MODEL	REV	CHANGE LIST	Model	CT3/5 MB BOARD	
			Page	FROM	TO
CT3/5 MB 31CT3MB0015 31CT3MB0031	1A	<p>PAGE 2 --- Enable CLK48M from clokc generator for the PLL circuit of 7411, and disable the ocsillator circuit of PCI7411 PLL.</p> <p>PAGE 3 --- Remove H/W shutdown circuit that supported ADM1032.</p> <p>PAGE 4 --- Use X7R type to replace Y5V type for CPU Decoupling/Bypass capacitor.</p> <p>PAGE 10 --- Add a terminal resistor R706 for -CODE_RST# to improve signal quality.</p> <p>PAGE 11 --- 1. Add a 10K pull-up resistor on MCH_SYNC# for booting. 2. Change the power plane of PCIE_WAKE# from 3VSUS to 3V_S5 to solve system can't turn off issue. 3. Change the power plane of ICH_THRM# and SCI_# from 3VSUS to +3V to reduce leakage.</p> <p>PAGE 12 --- We can also use 5VSUS to instead of 5V_S5 to save cost of MOSFET(A06402).</p> <p>PAGE 15 --- Add a level-shift cicuit for EDID interface.</p> <p>PAGE 17 --- 1. Add a off-page and a EMI solution for CLK48M. 2. Remove the reserve resistors (R693-R695) of parallel interface for PCI1510.</p> <p>PAGE 18 --- Remove R696, connect controller and power switch directly .</p> <p>PAGE 19 --- Change R682&R683 value from 56 ohms to 0 ohm cause of BOM error at

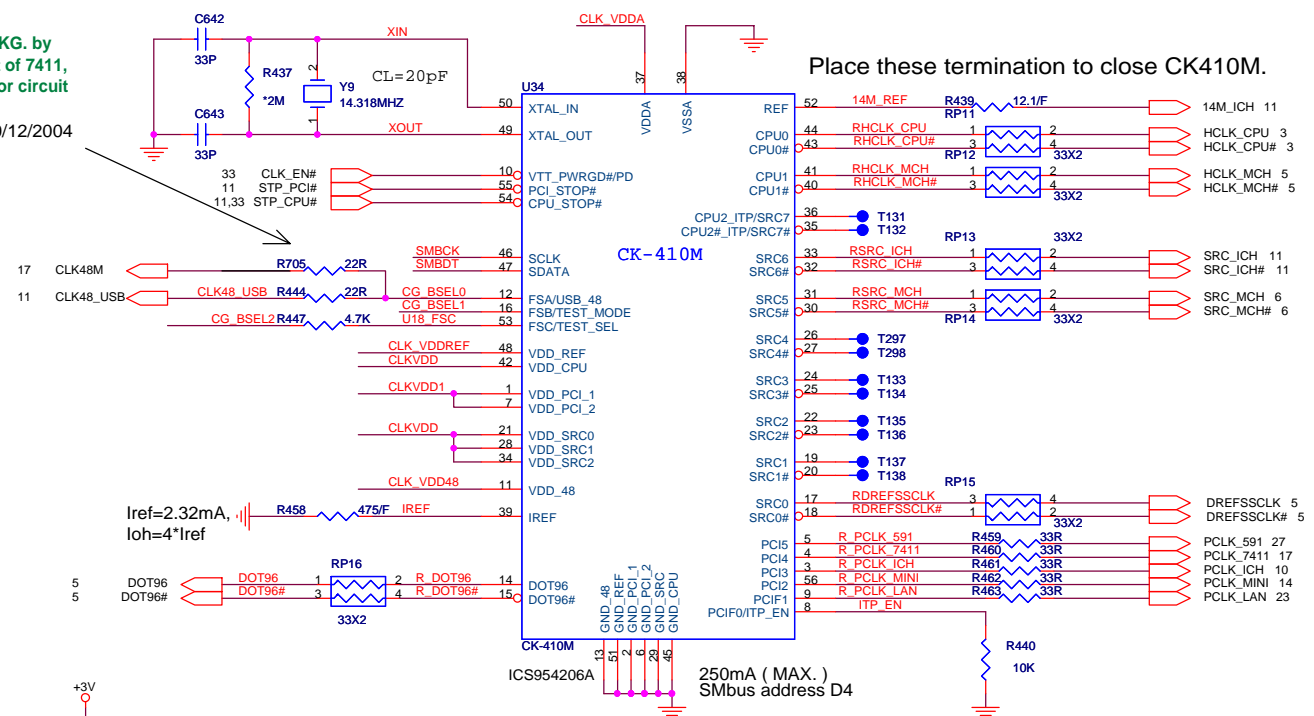
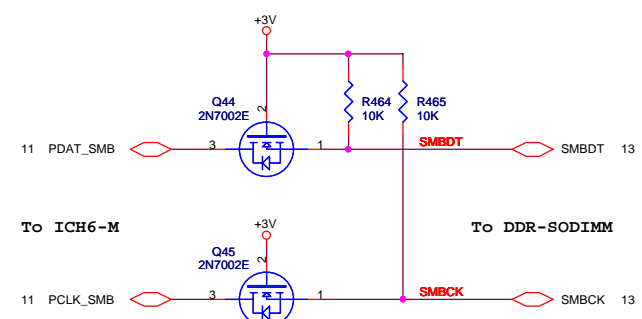
SI stage:
 Enable CLK48M from CKG. by
 R705 for the PLL circuit of 7411,
 and disable the oscillator circuit
 at PCI7411 side.

PV stage:
 Add C1048 for CLK48M to get better EMI
 performance.

CARDBUS POWER SWITCH

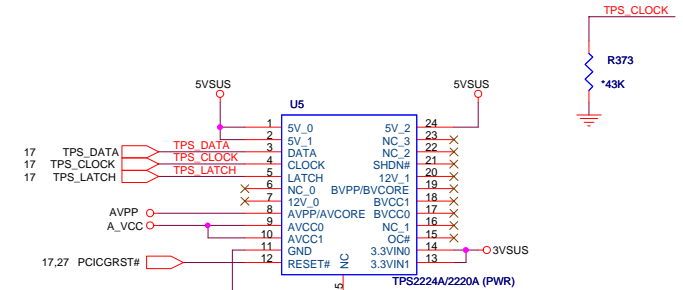
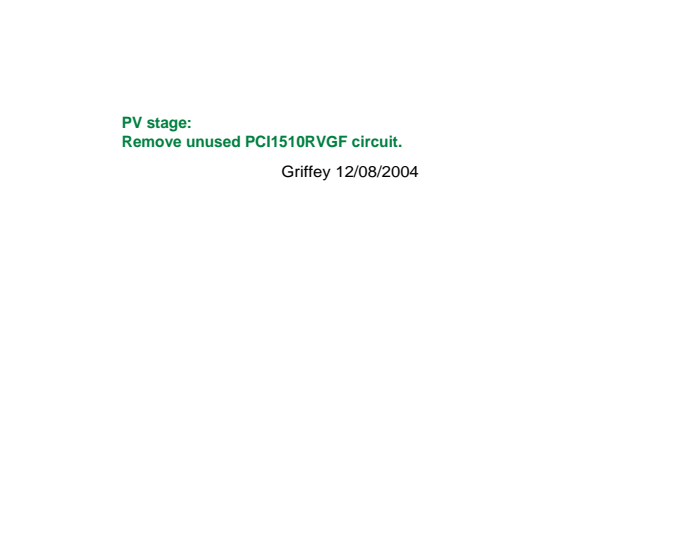
PV stage:
Remove unused PCI1510RVGF circuit.
Griffey 12/08/2004

IEEE 1394 CONNECTOR

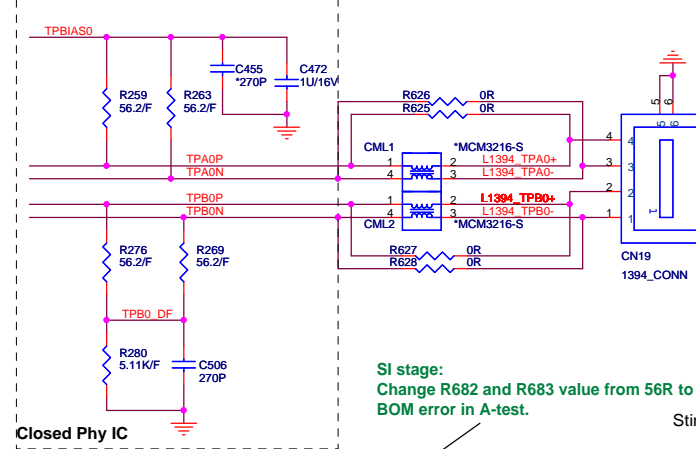
SI stage:
Change R682 and R683 value from 56R to 0R cause of BOM error in A-test.

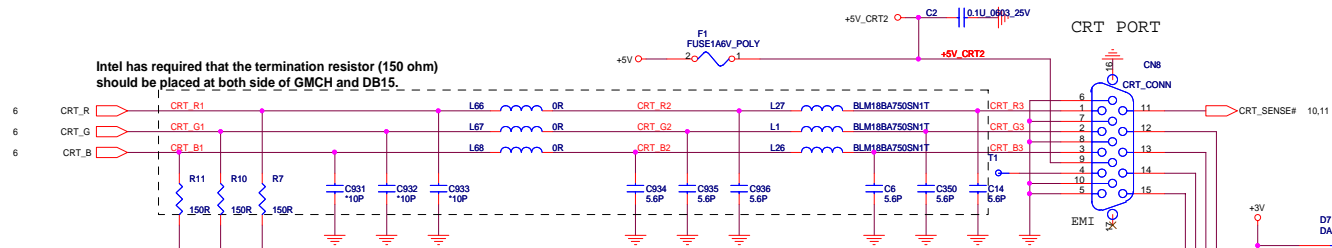
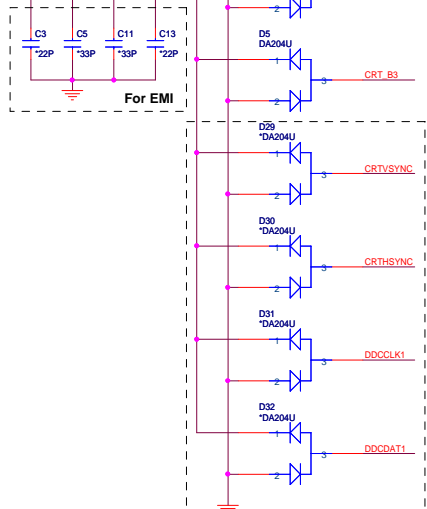
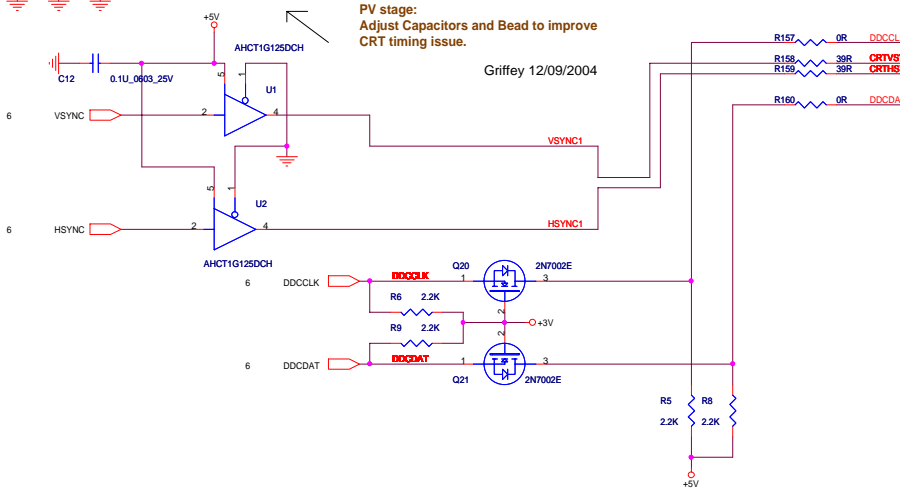
Intel has required that the termination resistor (150 ohm) should be placed at both side of GMCH and DB15.

PV stage: Adjust Capacitors and Bead to improve CRT timing issue.

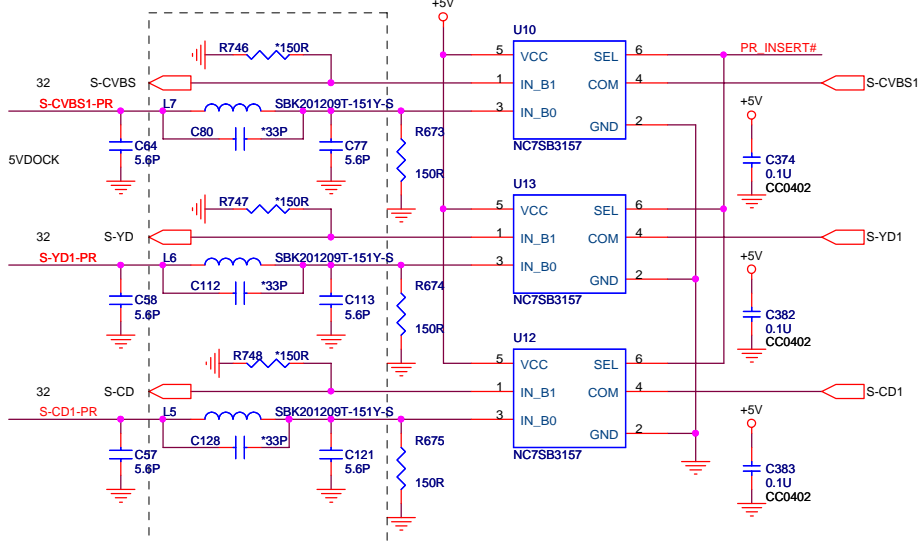
SI stage:
Add ESD protection circuit
by HP request. Sting 10/06/2004

PV stage:
1. Change L5,L6,L7,C57,C58,C64,C77,C113,C121 value to improve S-video quality.
2. Reserve S-video impedance match circuit.

SI stage:
Add R713 to enable the mux in the Tampa-2 cable.
(connects the component TV output to the composite/Svideo output lines).

Size	Document Number		Rev
Custom		CPU CORE POWER	2A
Date:	Monday, December 27, 2004	Sheet	33 of 39

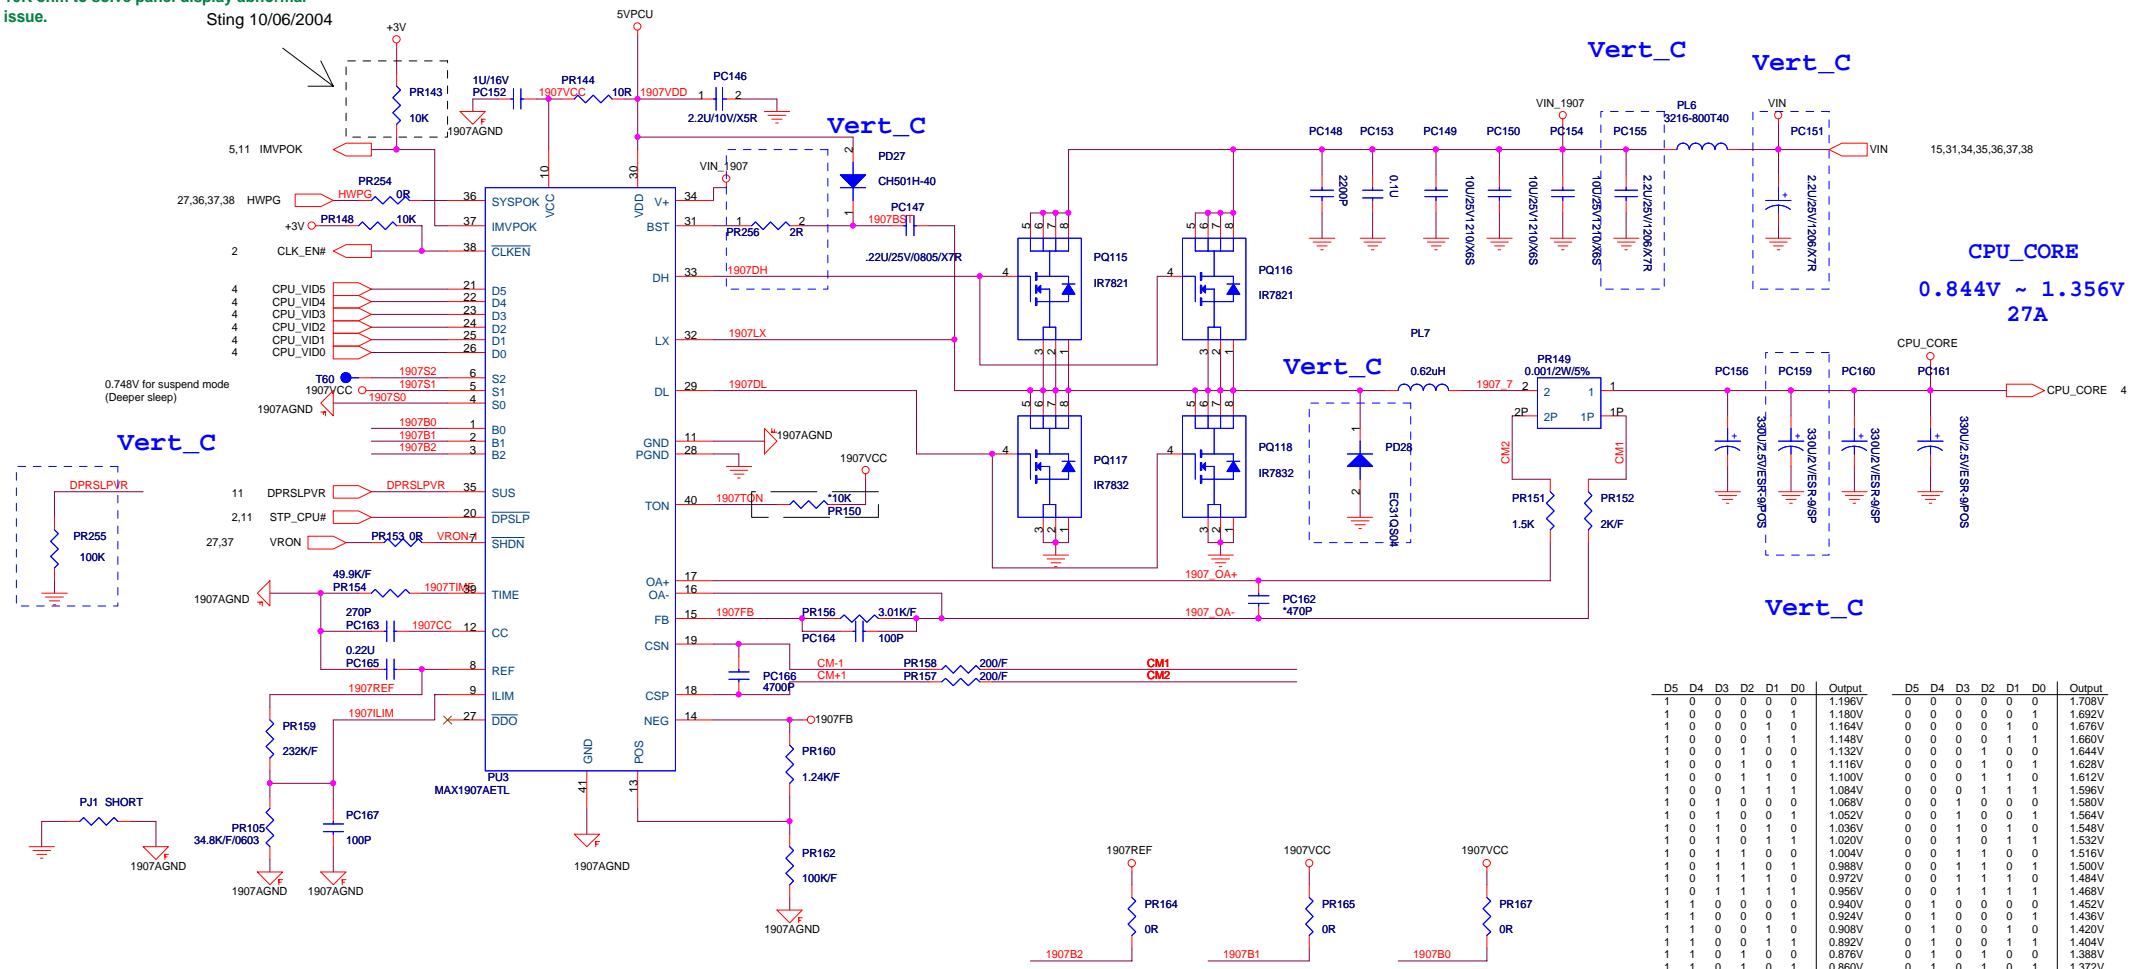
SI stage:
Change PR143 value from 100K ohms to
10K ohm to solve panel display abnormal
issue.
Sting 10/06/2004

PROJECT : CT3 Quanta Computer Inc.		Rev	2A
		Size	Custom
DISCHARGE		Sheet	35 of 39
Date:	Monday, December 27, 2004

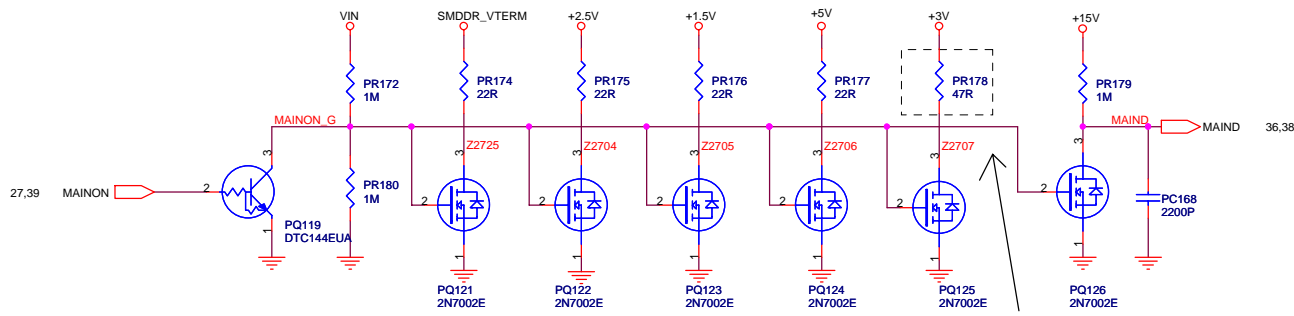
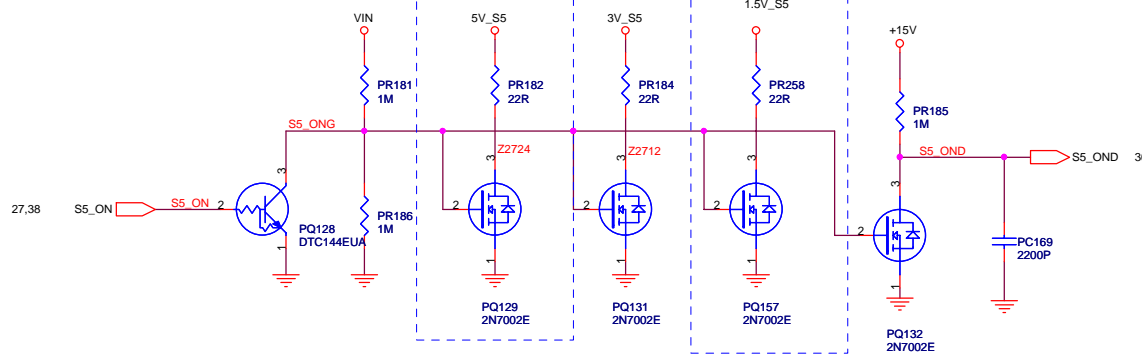
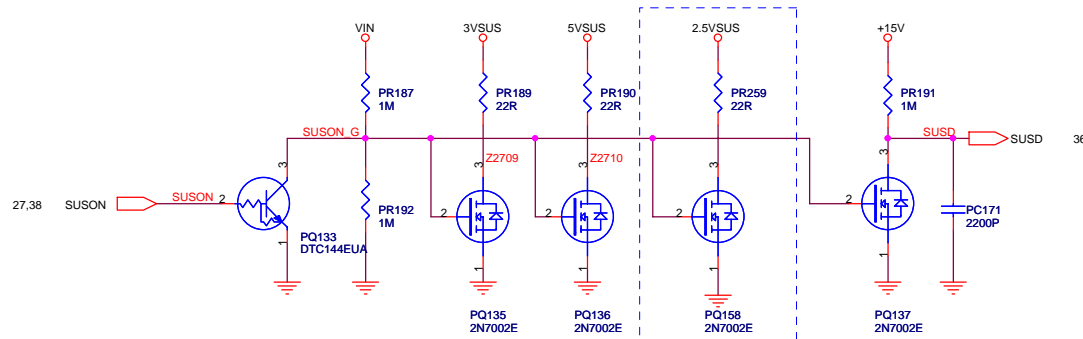
SI stage:
Change PR178 value from 22 ohm to 47 ohm, Intel has required the timing sequence of +1.5V and +3V in the system, we'd like to increase the value to make +3V discharge slowly to meet the specification of falling time.
